September 13, 2021

RE: Subdivision & Site Plan Approval
Bedford EMP Ownership, LLC - Robert Morse
50 East Middle Patent Road
North Castle (T)

Our office has revised our plans pursuant to the July 6, 2021, Staff Report prepared by the Town Planner and the July 9, 2021, memorandum prepared by Kellard Sessions, Consulting Town Engineer. We offer the following responses for the Board's consideration:

PRELIMINARY SUBDIVISION PLAT

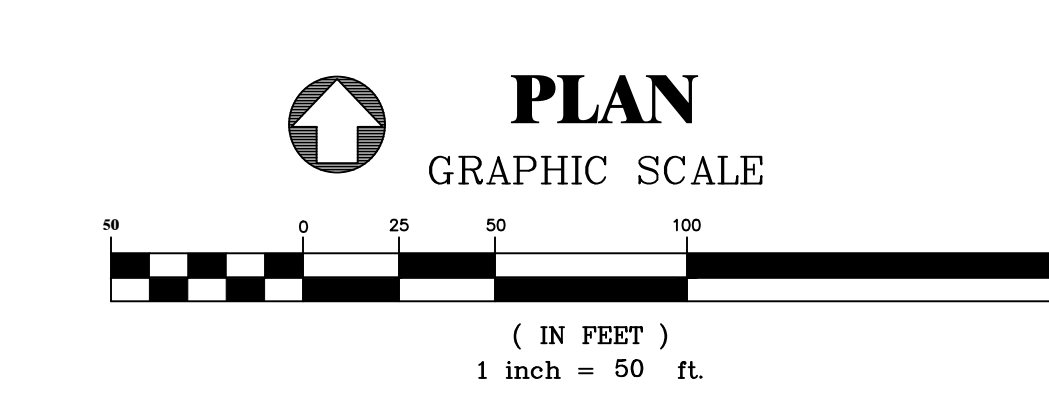
July 6, 2021, Staff Report prepared by the Town Planner:

1. The preliminary Plat has been revised to include the following:
 - Total acreage of the Subdivision has been added to the additional site / project information

- Names of the Owners of Record of adjoining and directly across the street properties have been added to the plan.
 - Areas reserved for Road Widening have not been counted in the revised gross or net lot area calculations.

15. Building envelopes have been revised to begin at the edge of the "area reserved for road widening".
16. Comment noted, recreation fees will be paid as required prior to filing of the subdivision plat.

12. Existing stone walls will not be removed as a result of this development.
13. The Preliminary Subdivision Plan has been retitled to "Preliminary Subdivision Plat".
